REQUEST FOR INFORMATION (RFI) VA250-17-R-0594

PROJECT NUMBER:	583-331	Please ensure that before submitting questions or requests for clarification that you thoroughly read the solicitation, specifications, drawings and other	
PROJECT TITLE:	Specialty Care Clinic		
PROJECT LOCATION:	Department of Veterans Affairs RLR VA Medical Center 1481 W. 10 th Street Indianapolis, IN 46202	the solicitation, specifications, drawings and other pertinent documents. When submitting questions on this project the Government requires contractors to specifically identify the specificatior and/or solicitation section(s) or drawing number(s) in reference to the question or request for clarification submitted. No question or request for clarification will be answered by the Government unless the above requirements are met. Failure to comply may prevent the Government from responding in a timely manner.	
	lim Erhart

RFI NO.: 4	DATE:12-27-17	SPEC/DWG. REFERENCE(s):	
KFINO 4		Section Cuts for Elevation 7/1-AS-412	
REPLY NEEDED BY:

TW219. - Cantilever

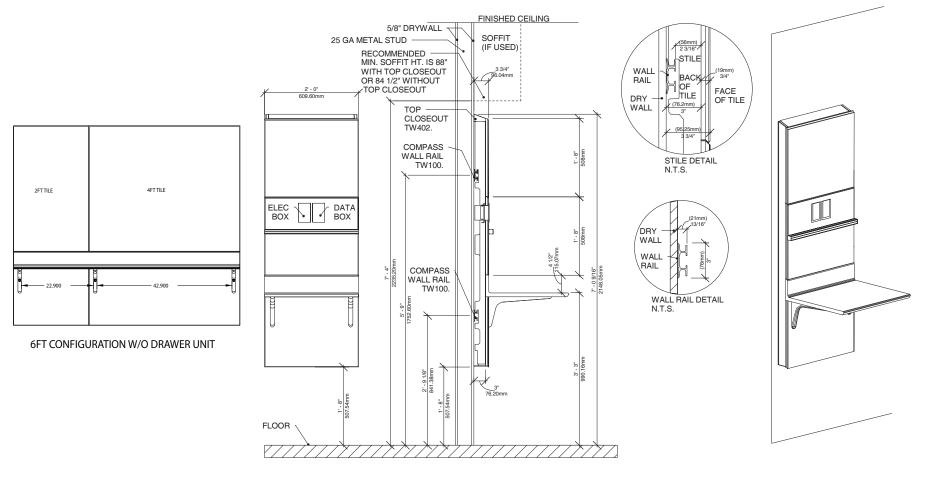
Please provide Section Cuts for Elevation 7/1-AS-412 to show how the casework all ties together. This elevation is not clear enough to interpret is what is needed to pick up.

Attached is an installation cut-sheet to provide additional detail.
